L-2011-150
10 CFR 50.90

Re: St. Lucie Plant Unit 1
Docket No. 50-335
Renewed License No. DPR-67

License Amendment Request for Extended Power Uprate

Figure 2.8.5.1.1-9
Increase in Steam Flow (HZP)
Peak Fuel Centerline Temperature

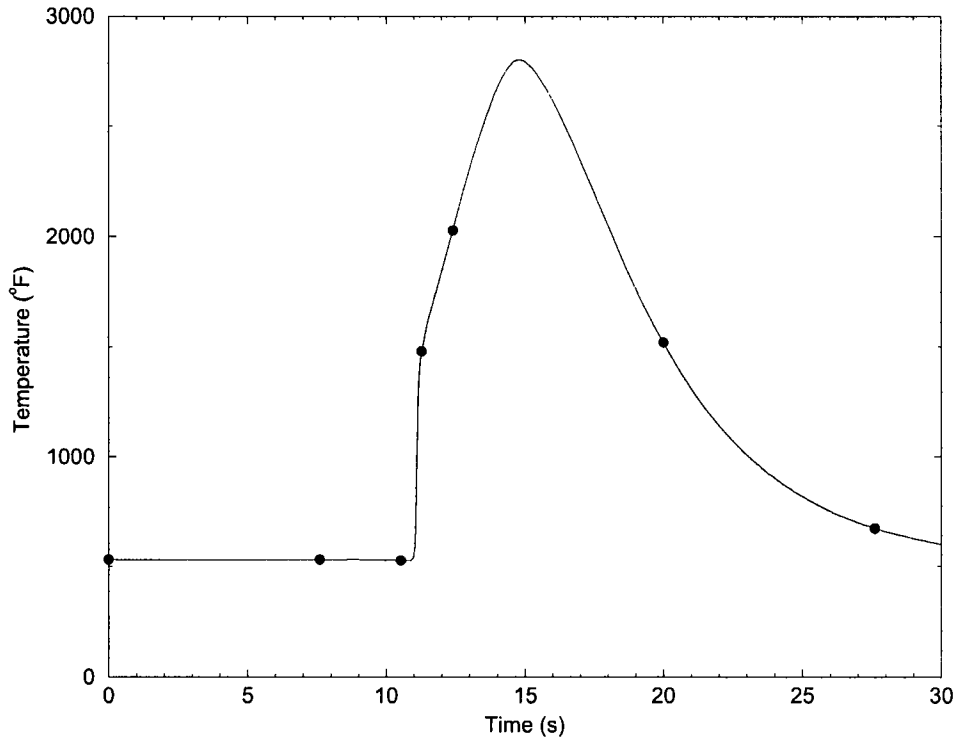
Subsequent to the November 22, 2010 submittal, FPL was notified by a supporting vendor that an error was identified in the St. Lucie Unit 1 Extended Power Uprate (EPU) Increase in Steam Flow analysis. The error affects the analysis results provided in Licensing Report (LR) 2.8.5.1.1 of Attachment 5 of FPL letter L-2010-259. Attachment 1 to this letter provides the revised pages of LR 2.8.5.1.1 with the error corrected. The revised pages consist of replacement tables and figures associated with the Increase in Steam Flow analysis results and supersede the corresponding tables and figures provided in Attachment 5 of L-2010-259. The error also affects LR 2.8.5.0 of Attachment 5 of L-2010-259; however, the impact on LR 2.8.5.0 is a conforming change only and is limited to the Table 2.8.5.0-10 summary of analysis limits and results to reflect the revised maximum centerline temperature from the Increase in Steam Flow analysis results.

| Criterion | HZP | HFP | Limit |
|-----------------------------|-------------------|------------|--------------|
| Peak Centerline Temperature | 2,804°F | N/A | 4,623°F |
